MEMORANDUM FOR THE RECORD

SUBJECT: 21 BON 104 Navigation Lock 1 (old navlock) Bridge Replacement

Subject: RE: BN NL bridge - Draft 30% PS Quality checks review

Figure 1 - General site layout for Bonneville Dam Navigation Lock 1 Swing Bridge Replacement. Area circled in red indicates where sea lion traps are operated by other entities.

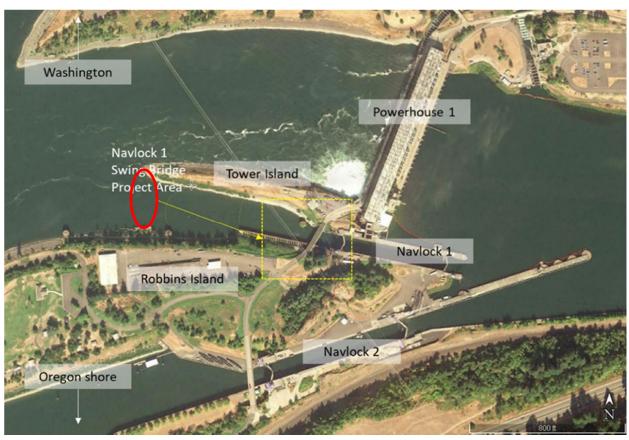
- Sea lion management efforts occurs towards the tail end of the old navigation lock (Figure 1). Construction activities will be coordinated with this group such that they do not negatively impact implementation of sea lion management efforts.

In looking through the 30% design for this project, my comments pertinent to this stage of design are minor and I will put them in Dr Checks (ensure seal lion haul out areas are avoided during construction and in final design; consider tailrace sea lion mgmt during construction; consider FPOM distance from adult ladder requirements (50/100ft) for construction activities).
